ADDENDUM NUMBER 1

CITY OF BEAVERTON

SANDBERG SUBDIVISION SANITARY SEWER REHABILITATION PROJECT FISCAL YEAR 2005-06

April 19, 2006

ENGINEERING DEPARTMENT		STANDARD RESIDENTIAL DRIVEWAY			
	CITY ENGINEER	DA	TE	DRAWN BY	DRAWING NO.	
City Of Beaverton	Terry Waldele, P.E	7 - 13	- 04	JCH - CPD	211

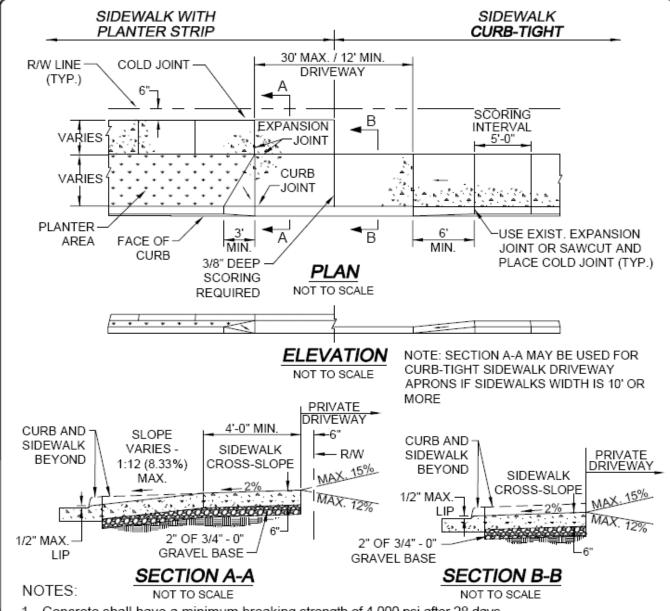
A-13 Concrete Driveway, 6" - Payment for this item shall be on a square foot (SF) basis to the nearest square yard for all labor, equipment, and materials to place and finish the 6" thick concrete driveway in accordance with City standard detail 211. Work includes removal and disposal of the existing driveway, placement and compaction of 2" of 34"-0" base rock, wire mesh, concrete and expansion joint material. The pay area includes the driveway approach, driveway wings, and sidewalk connection to the driveway. Work also includes the phasing required to maintain one way access at all times and protecting the concrete from vandalism or other damage (repair of damage will be at no cost to the City). Top of driveway will match top of adjacent driveway.
